UNITED STATES PATENT AND TRADEMARK OFFICE

APPLICATION NO.	FILING DATE	FIRST NAMED INVENTOR	ATTORNEY DOCKET NO.	CONFIRMATION NO.
09/601,545	03/29/2001	Francois Breynaert	60130-865	7785

Office Action Summary

DETAILED ACTION

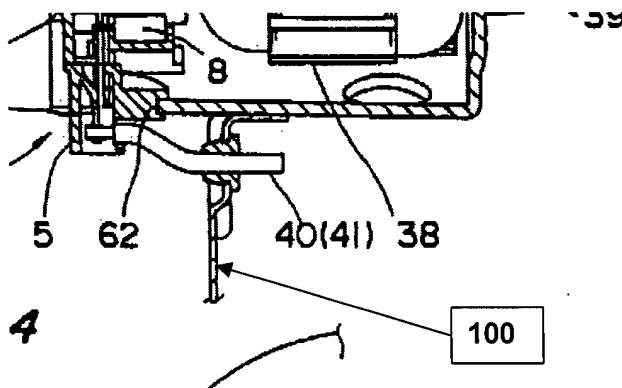
Takiguchi clearly teaches the construction of a noise suppression system for a permanent-magnet motor (1), in which:

the motor includes supply brushes (26, 27) connected to an external power supply by leads (40, 41), which are associated with inductors (6, 7);

and a metal casing (5), characterized in that:

each brush is connected to the metal casing of the motor through at least one noise suppression capacitor (8),

in that the metal casing of the motor is connected to the vehicle's earth, and

that the metal casing of the motor and the functional device have complementary means (100, added by the examiner) for earthing the casing.

However, it fails to disclose each of said brushes is separately connected to said casing by at least one noise suppression capacitor.
